URBAN DESIGN REVIEW WATERLOO ESTATE SOUTH

Hassell has been engaged by DPIE to undertake a 'broad and holistic' urban design review of the Waterloo Estate (South) Planning Proposal prepared by the City of Sydney.

Planning Proposal

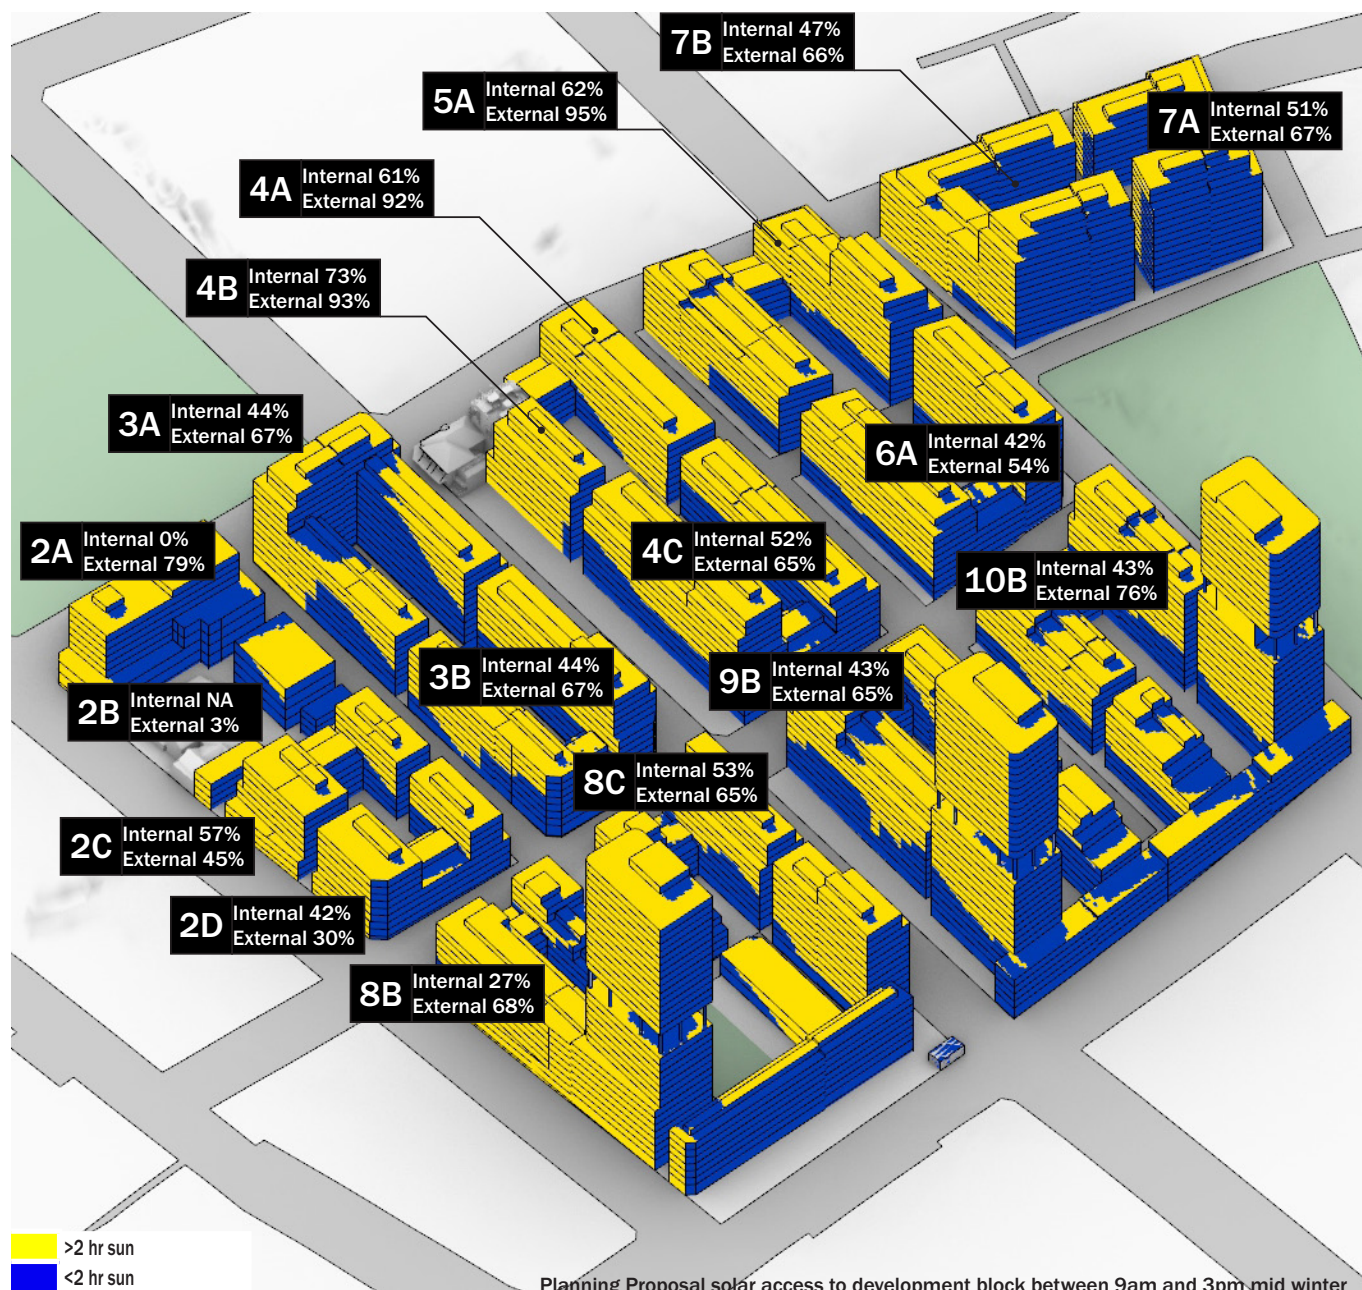
- Due to the height of the buildings proposed, the facade of the buildings are self shaded and overshadowed by adjacent buildings.
- The blocks in the centre of the precinct are the most impacted.
- The external percentage demonstrates in particular the east and west facades where the living rooms and POS will likely be located and the likelihood of compliance.

02 - Dual Aspect

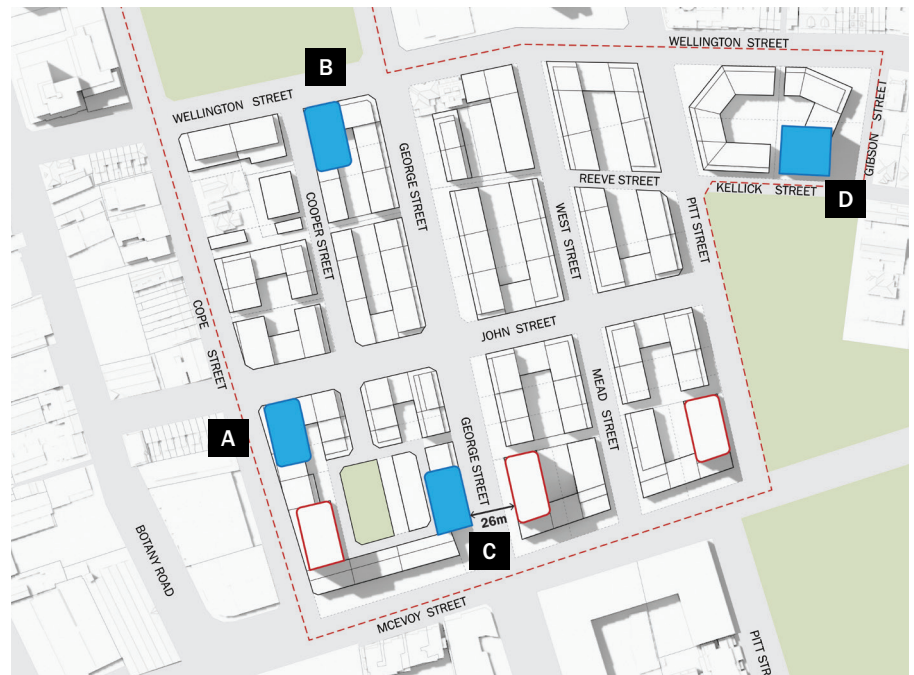
- If living room and POS are located on the western facade, Living room located behind POS
- Due to the orientation of the building/envelope, the living room does not achieve ADG solar access requirement, resulting in a non compliant apartment.

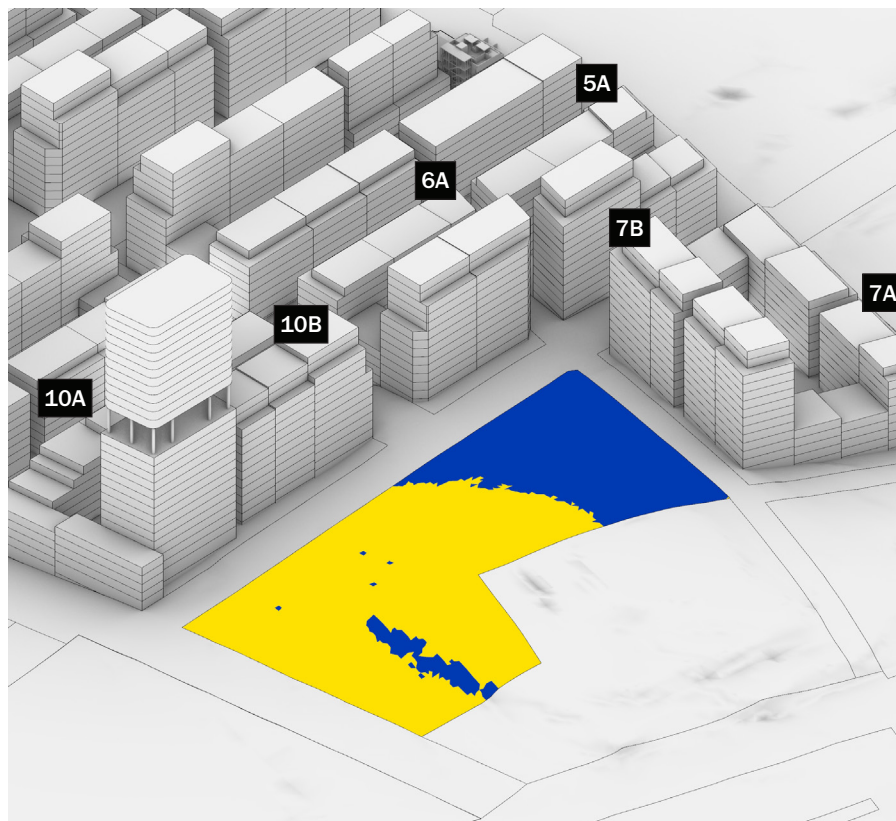
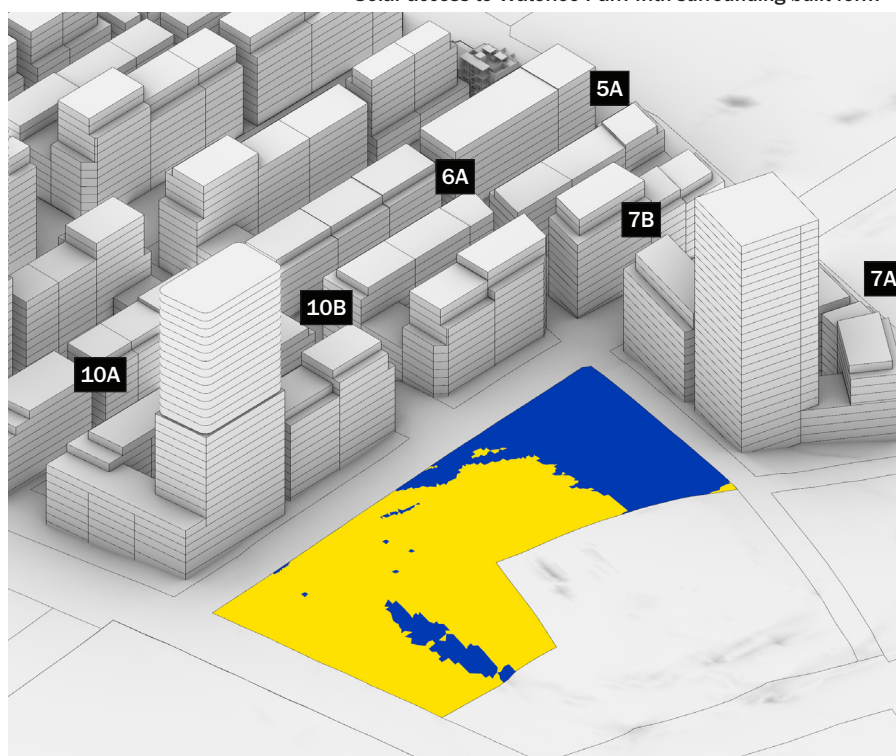
- In Shadow = 38% / 4836 sqm
- In Sun = 62% / 7812 sqm
- (A minimum of 4 hours+ of 50% of solar access required in winter)

- In Shadow = 37% / 4685 sqm
- In Sun = 63% / 7963 sqm
- (A minimum of 4 hours+ of 50% of solar access required in winter)

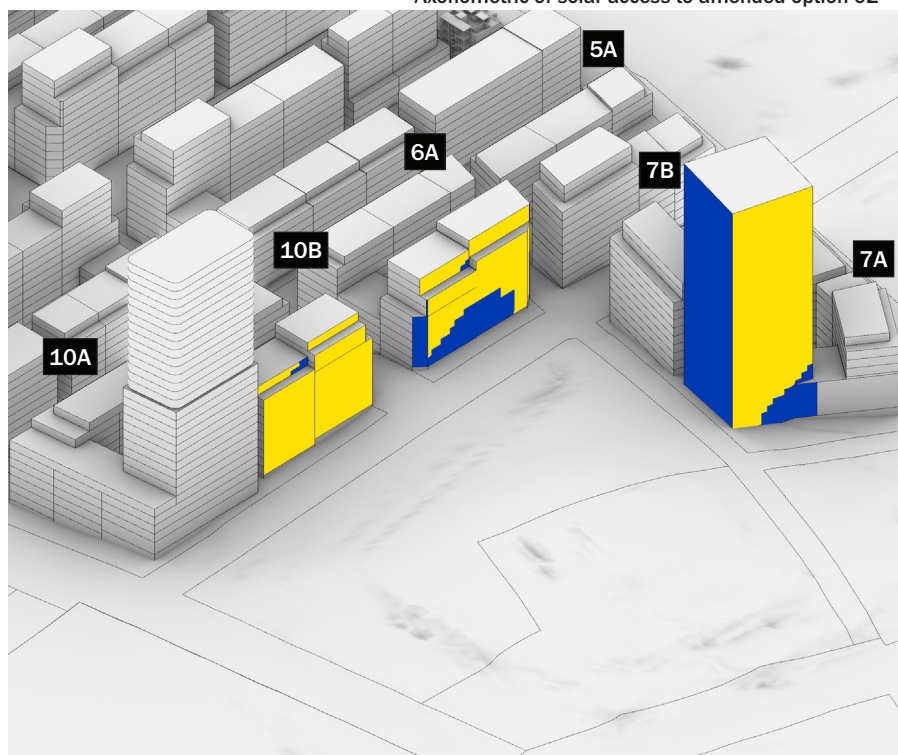
- **Block 6A:**
 - In Shadow = 36% / 735 sqm
 - In Sun = 64% / 1290 sqm
 - (A minimum of 2 hours+ of 50% of solar access required in winter)
- **Block 10B:**
 - In Shadow = 0.5% / 10 sqm
 - In Sun = 99.5% / 2158 sqm
 - (A minimum of 2 hours+ of 50% of solar access required in winter)

View from Redfern Park looking south west

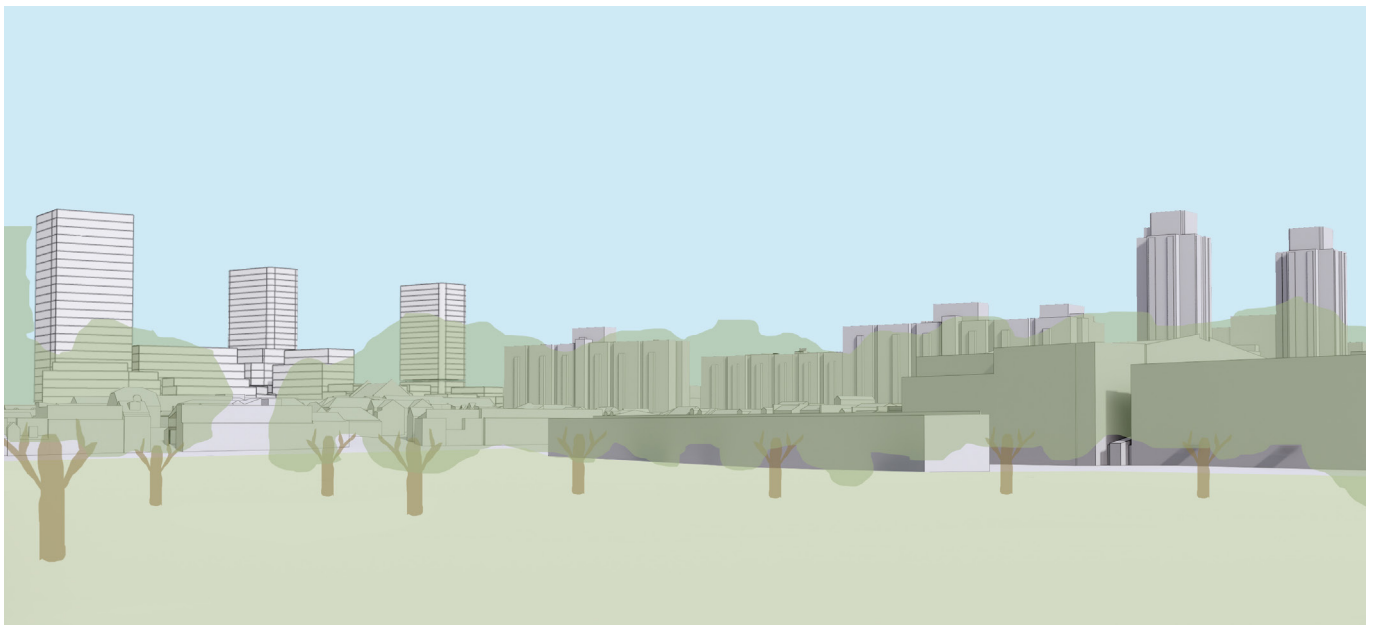
Above, City of Sydney proposal
Below, Amended envelope

View from Alexandria Park looking east

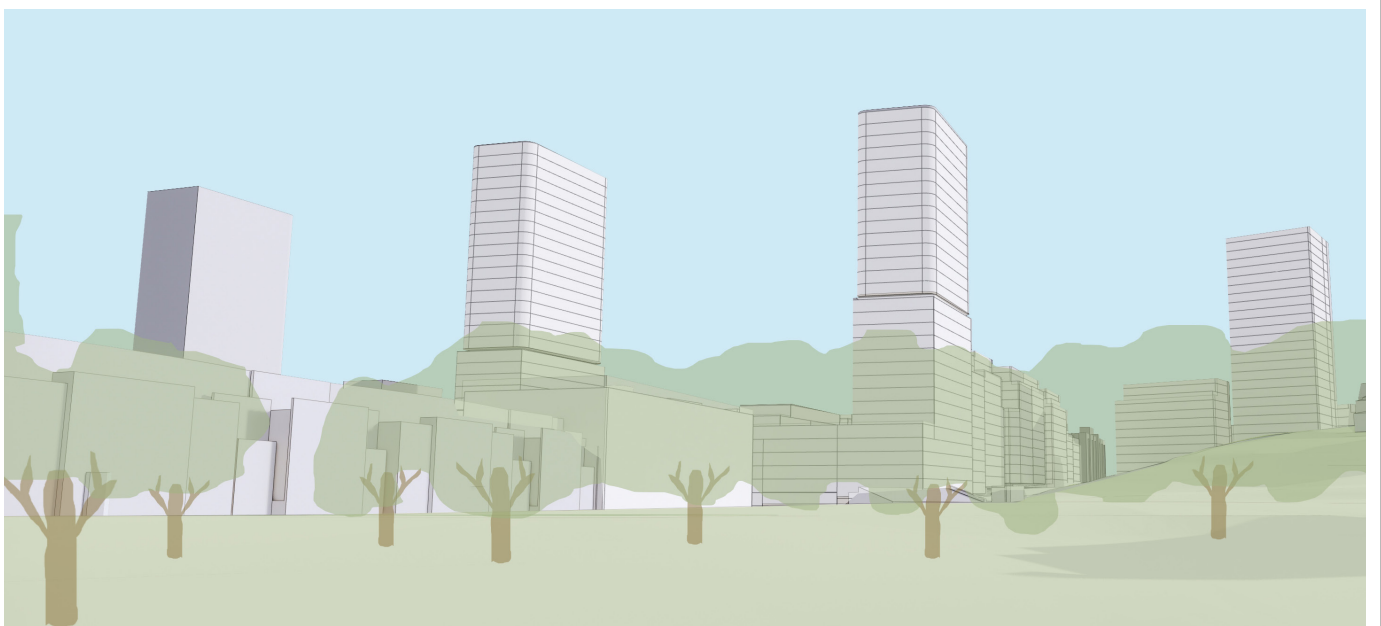
Above, City of Sydney proposal
Below, Amended envelope

View from large park looking south

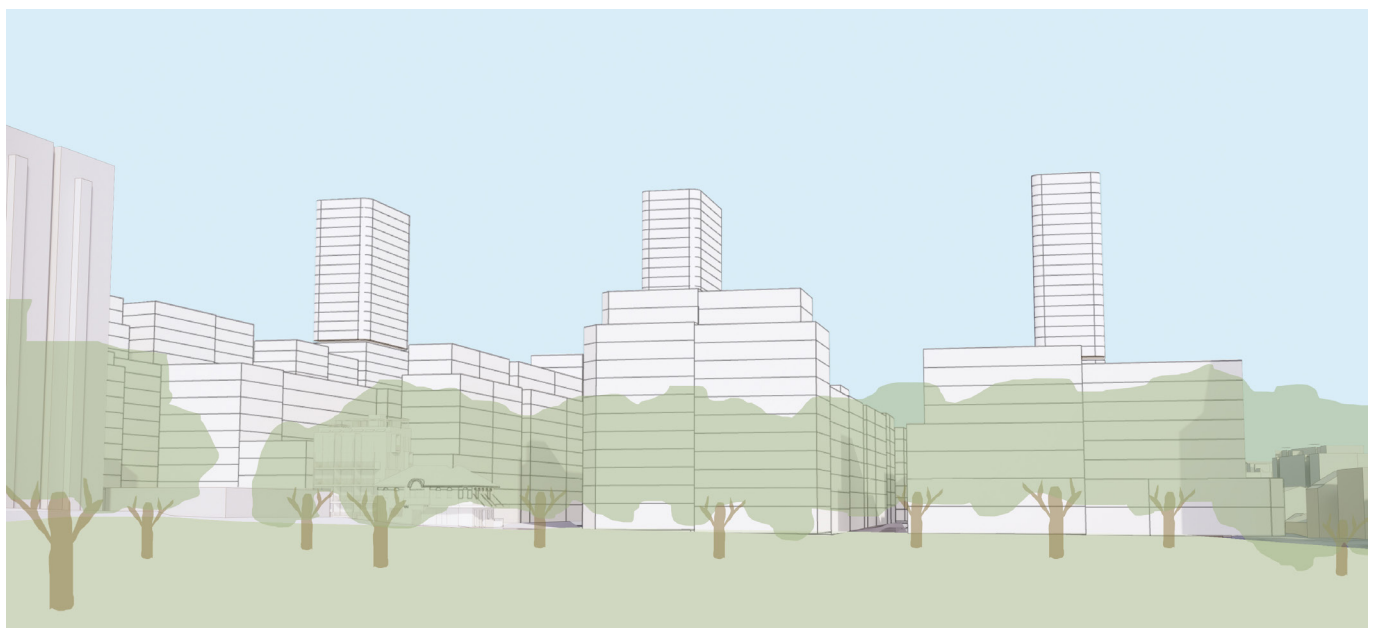
Above, City of Sydney proposal
Below, Amended envelope
